## ASSESSMENT REPORT

### ***Sydney International Convention, Exhibition and Entertainment Precinct (SICEEP), Core Facilities, Darling Harbour SSD 5752 MOD 3***

**Figure 3:** Core Facilities approved building layout and public domain (Source: Assessment report SSD 5752) (Note: area subject to Condition C1(a) in **BLUE**)

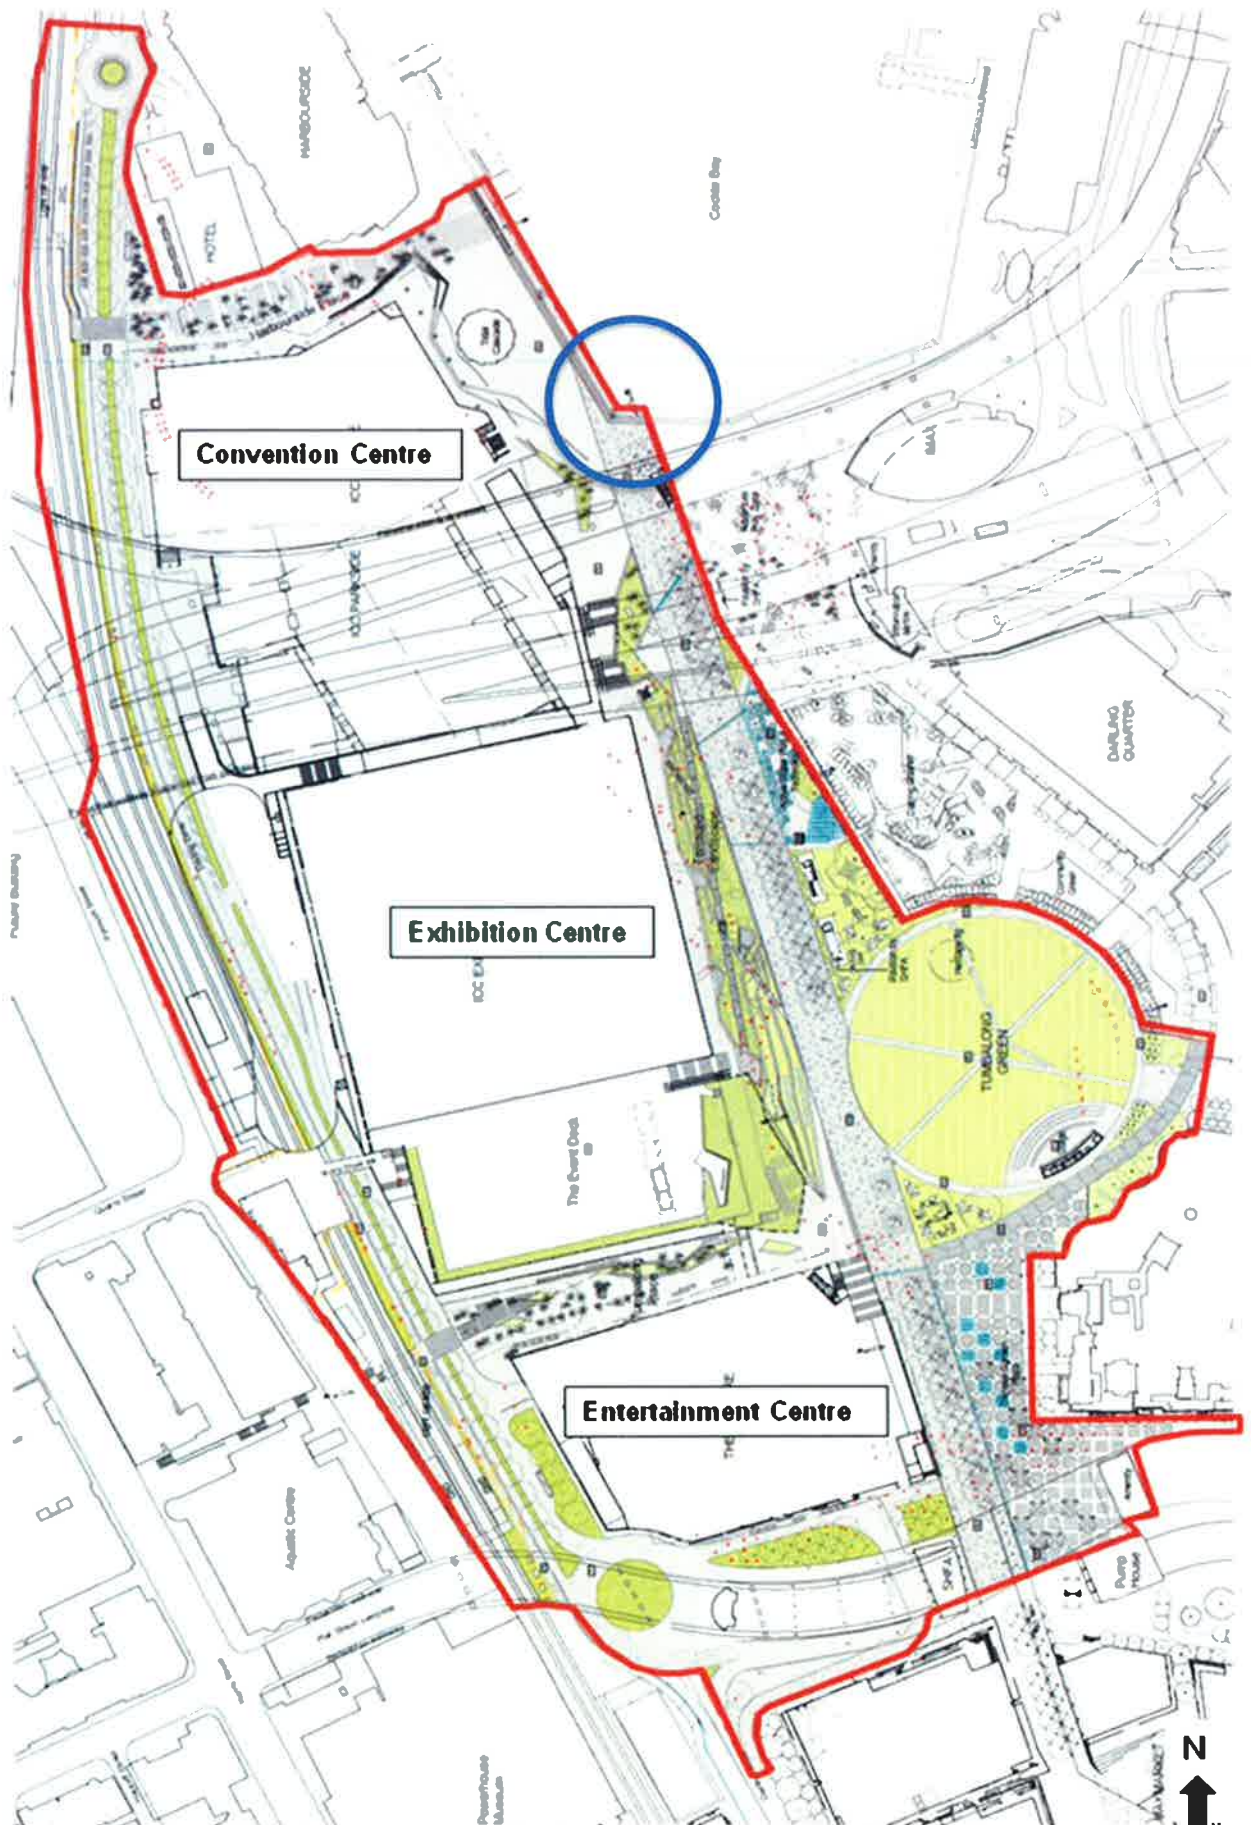
- outside of the project boundary for the original approval for SSD 5752 (Figures 3 & 4);
- not supported by Sydney Harbour Foreshore Authority (SHFA); and
- inconsistent with SHFA's current public domain proposal for Cockle Bay as detailed in the State Significant Development Application - Cockle Bay Marine Structures Renewal (SSD 6611), which is currently on public exhibition.

**Figure 4:** City of Sydney Council original submission with the suggested alternative termination of The Boulevard extending over Cockle Bay outlined in **RED** (Source: City of Sydney Council submission to original EIS)

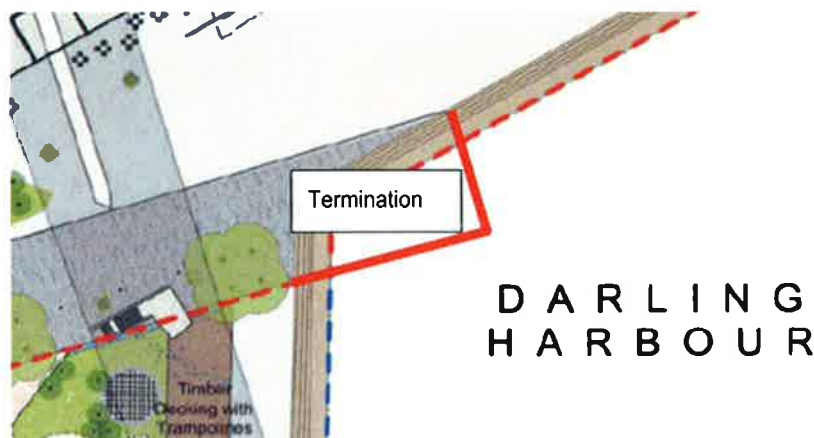
This condition was placed on the consent in response to a submission from the City of Sydney Council (Council) to the original application suggesting that The Boulevard extend beyond the SICEEP Project Area over Cockle Bay (Figure 4).

Following public exhibition of the original application, Council raised concern with the treatment of the northern termination of The Boulevard as part of its submission (Figure 4). The relevant extract from Council's submission is detailed below:

#### ***...Termination of The Boulevard***

*It is suggested that the northern end of The Boulevard needs termination where it reaches Cockle Bay. Otherwise it blends with the surrounds and is unlikely to have the desired effect of marking the entry and exit to and from the PPP facilities...*

Since that time, it has become apparent that Council's suggested alignment of the northern termination of The Boulevard (Figure 4) is problematic for the following key reasons:

- it extends beyond the project area and outside the scope of the project and responsibility of the applicant; and
- it is inconsistent with SHFA's proposed renewal for Cockle Bay (SSD 6611).

The Department's assessment concludes that an alternative alignment for northern termination of The Boulevard (particularly as suggested by Council over Cockle Bay) is inconsistent with the above proposal and is not considered to lead to significant public domain improvements.

In this regard, the original alignment for this area as proposed in the SICEPP project is considered an appropriate public domain outcome in the context of the proposed Cockle Bay renewal works.

A revised scheme for the ground surface treatment at this point would still be required under the condition to ensure that the ground surface is designed to provide an appropriate interface with the adjoining surface treatments at the boundary. A minor amendment to the wording of the condition is recommended to ensure this requirement is clear. The amended condition would read:

- a) *A revised design scheme providing a revised ground surface treatment ~~and alignment~~ of at the northern termination point of The Boulevard, at Cockle Bay.*

**Figure 6:** Overlay of Proposed Scheme over Existing, with area subject to Condition C1(a) in **RED**  
(Source: SSD 6611 EIS)

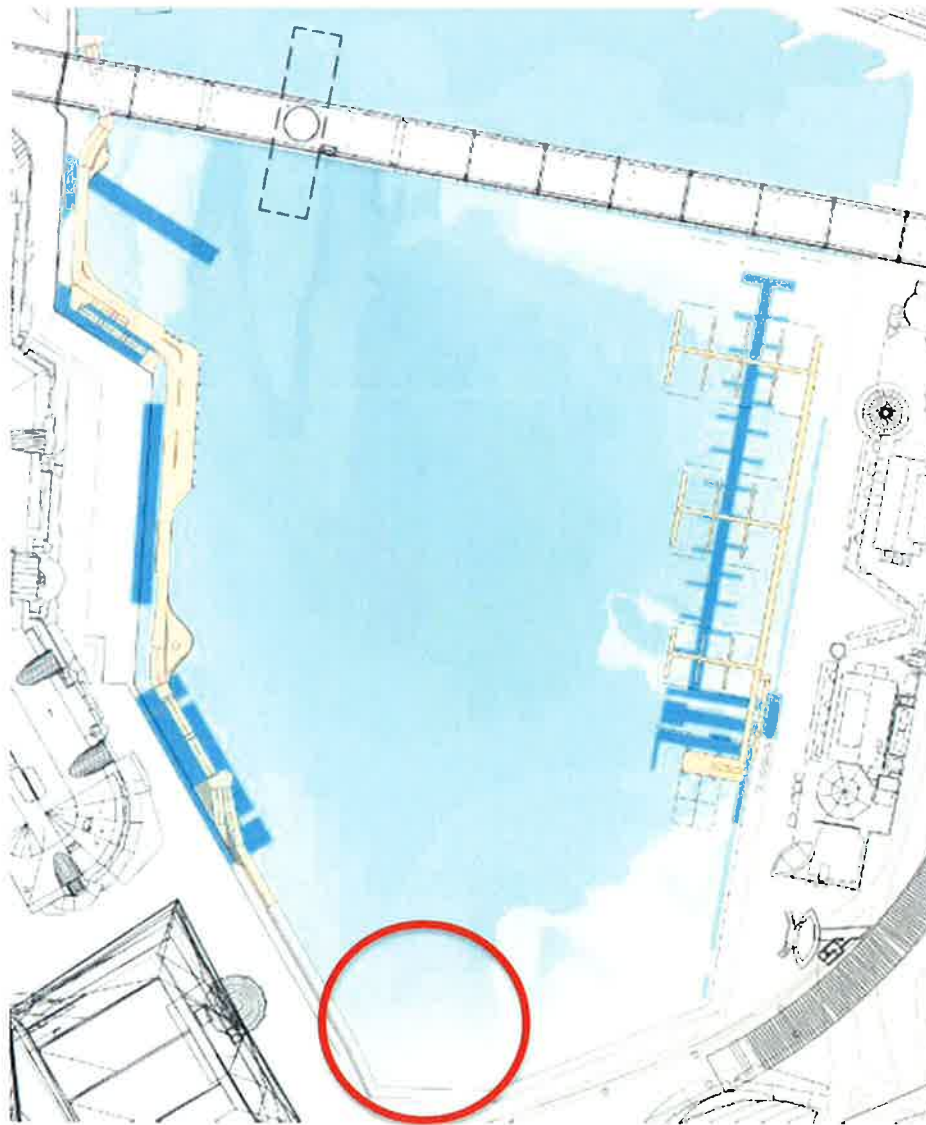
These proposed works do **not** include any work at the termination of the Boulevard. The EIS maintains that this proposal will enhance this area for public entertainment and events in and around ICC Sydney and Darling Harbour.

The proposal seeks to de-clutter existing marine structures in Cockle Bay and provide links with other public domain work, including the SICEEP approval to create a linkage to the broader precinct as detailed in the EIS below:
